DOCKETS 50-266 AND 50-301 TECHNICAL SPECIFCATIONS CHANGE REQUEST 219 ADOPTION OF PRESSURE AND TEMPERATURE LIMITS REPORT AND REVISED P-T AND LTOP LIMITS POINT BEACH NUCLEAR PLANT, UNITS 1 AND 2

DOCKETS 50-266 AND 50-301 TECHNICAL SPECIFICATIONS CHANGE REQUEST 219 ADOPTION OF PRESSURE TEMPERATURE LIMITS REPORT AND REVISED P-T AND LTOP LIMITS POINT BEACH NUCLEAR PLANT, UNITS 1 AND 2 DESCRIPTIONS AND BASES FOR PROPOSED CHANGES

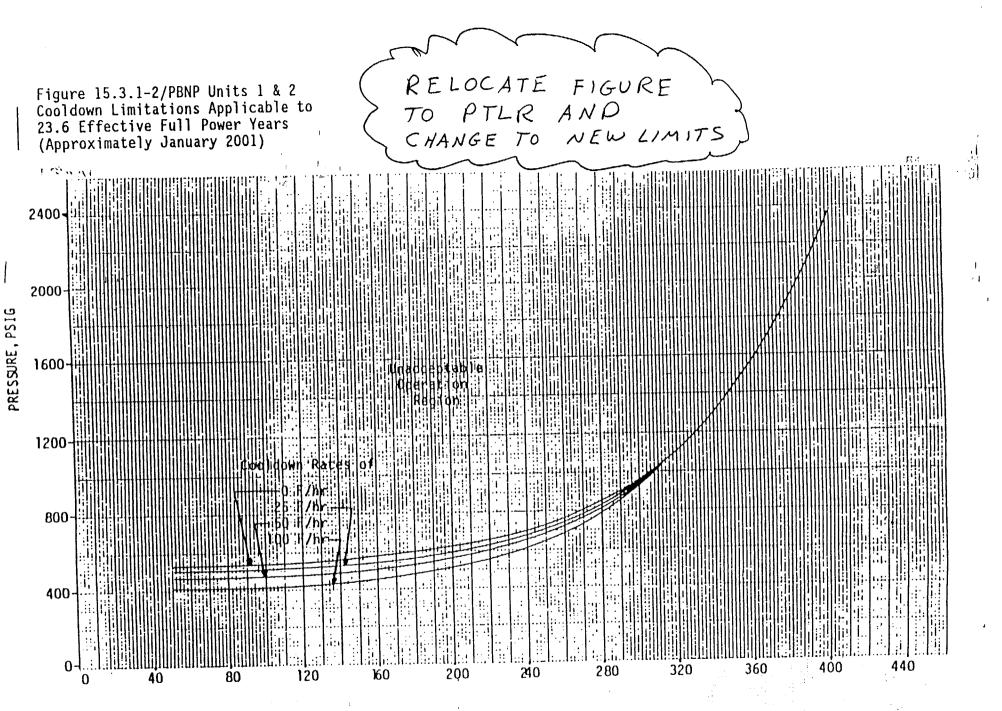
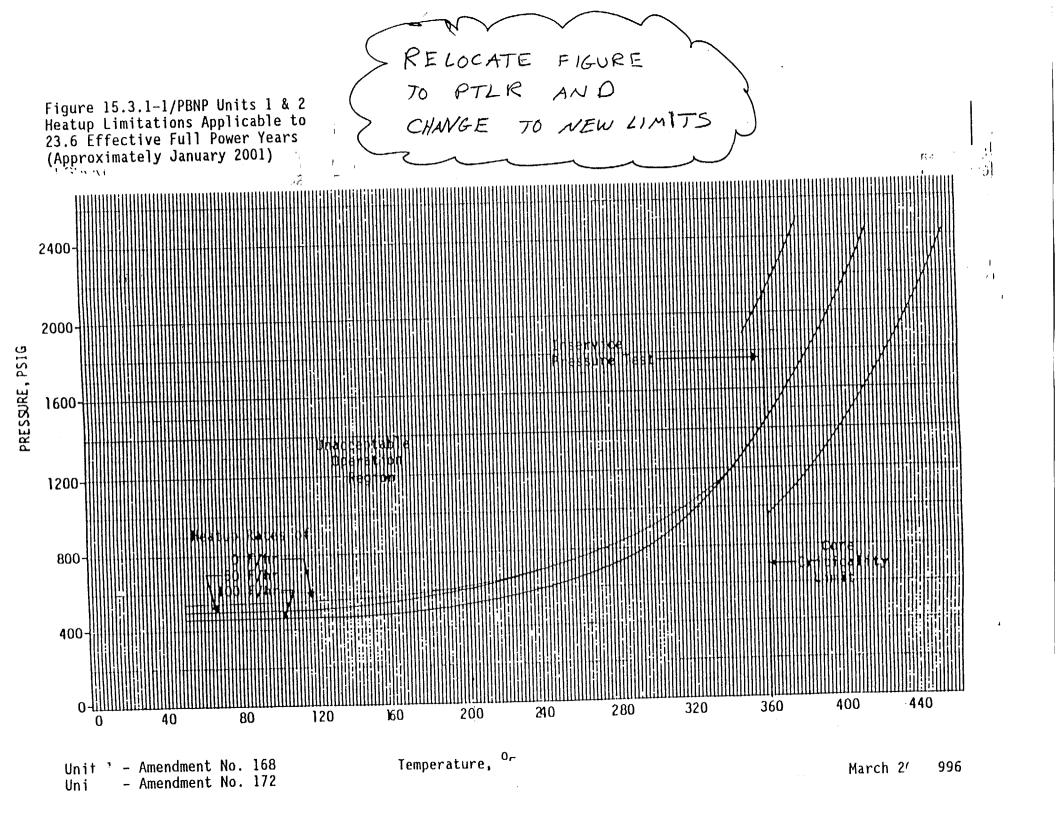
Relocate the Reactor Coolant System temperature and pressure limits shown on TS Figures 15.3.1-1 and 15.3.1-2 and the heatup and cooldown limits contained in TS 15.3.1.B.1.a, b, and c to the PTLR. Additionally, the Reactor Coolant System temperature and pressure limits shown on Figures 15.3.1-1 and 15.3.1-2 are expiring in 2001 and the new curves are provided. These curves are based on new analyses contained in the attached information.

- The Reactor Coolant System temperature and pressure shall be limited in accordance with the limit lines shown in Figure 15.3.1-1 and 15.3.1-2 during heatup, cooldown, criticality, and inservice leak and hydrostatic testing with:

TO PTLR RELOCATE

Figure 1. RCS Pressure-Temperature Limits for Heatup

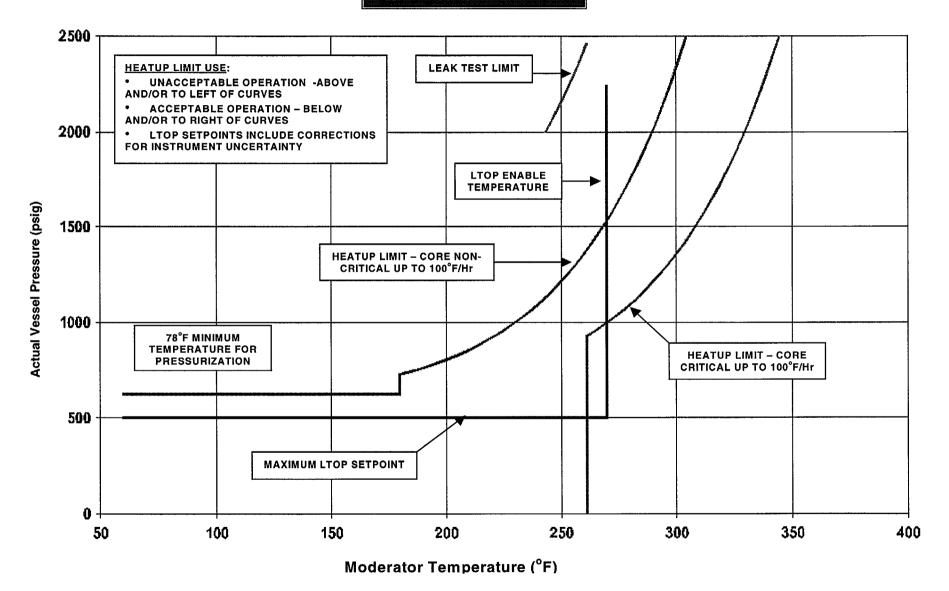
In addition, Figures 1 and 2 are provided as figures suitable for inclusion in the Pressure Temperature Limits Report based on the output of P-T Calculator for Windows. These figures include additional annotations and guidance to provide the most useful figures for the plant reactor operators.

This calculation provides heatup and cooldown pressure-temperature limits (Figures 1 and 2) applicable through the expiration of the Point Beach Units 1 and 2 Operating Licenses, and demonstrates that a Technical Specification LTOP setpoint of 500 psig with LTOP enable temperature of 270°F will provide acceptable protection of the reactor vessel from mass injection and heat-injection overpressure events at low temperatures through the expiration of the Point Beach Units 1 and 2 Operating Licenses.
